PRESERVATION BOARD REGULAR MEETING MONDAY, NOVEMBER 20, 2023 — 4:00 P.M.

Preliminary Review:	JURISDICTION:	PROJECT:	PAGE:
A. 1514 Mallinckrodt Street	Hyde Park HD	Construct 2-story single-familybuilding	1
BPS Referrals:	JURISDICTION:	PROJECT:	PAGE:
B. 3900 Holly Hills Boulevard	City Park	Construct vehicle gates at 5entrances to Carondelet Park	9
C. 6000 Chippewa Street	Encroachment	Install aluminum banners onlight poles on Hampton Avenue	12
Appeals of Director's Denials:	JURISDICTION:	PROJECT:	PAGE:
D. 2326 Russell Boulevard	McKinley Heights HD	Appeal of Director's Denial toconstruct non-compliant carport	13
D. 2326 Russell Boulevard E. 50 Waterman Place	, ,	construct non-compliant carport

ADDRESS: 1514 Mallinckrodt Street

ITEM: Construct 2-story single-family building
JURISDICTION: Hyde Park Certified Local Historic District

PROPOSED SITE PLAN

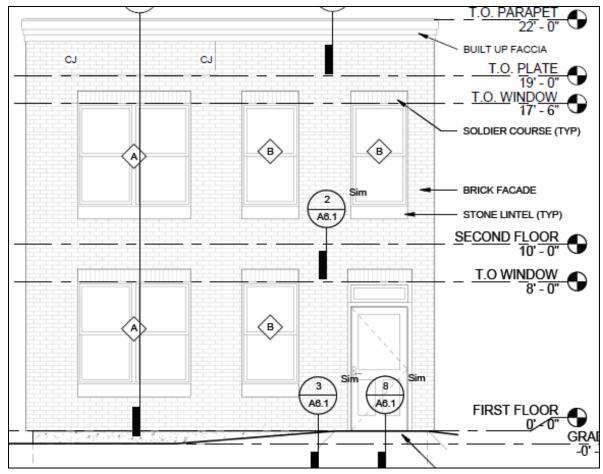
Complies. The side yards of the building are slightly wider than those of the rest of the block. However, the proposed side yards closely reflect the side yards of the building previously on the site.

Complies. The parking would be accessed from the alley.

PROPOSED FRONT FACADE

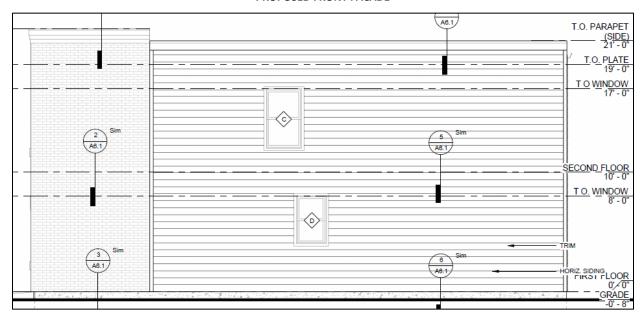
Complies. The front façade and east and west returns would be red brick. The remaining siding on the sides and rear would be a color that matches the red brick. Hardie-board (or equivalent) siding in a color that matches the brick would be used on the sides of the building.

Complies. Proposed details are compatible with the adjacent buildings. Fenestration size is derived from an average of windows of buildings on the street.

PROPOSED SIDE PORCH

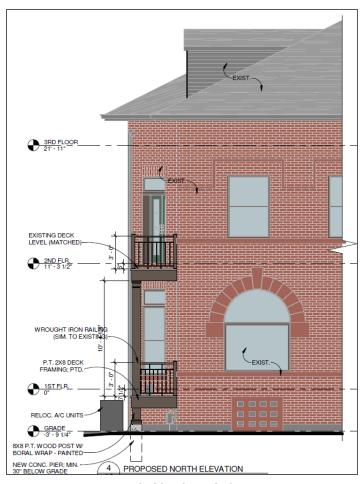
Does not comply. The proposed porch does not replicate the existing balcony and original lower balcony as a support column has been added. The existing handrail is not being replicated and the proposed decking would be composite. There would also be an 8-inch concrete footing visible from the street.
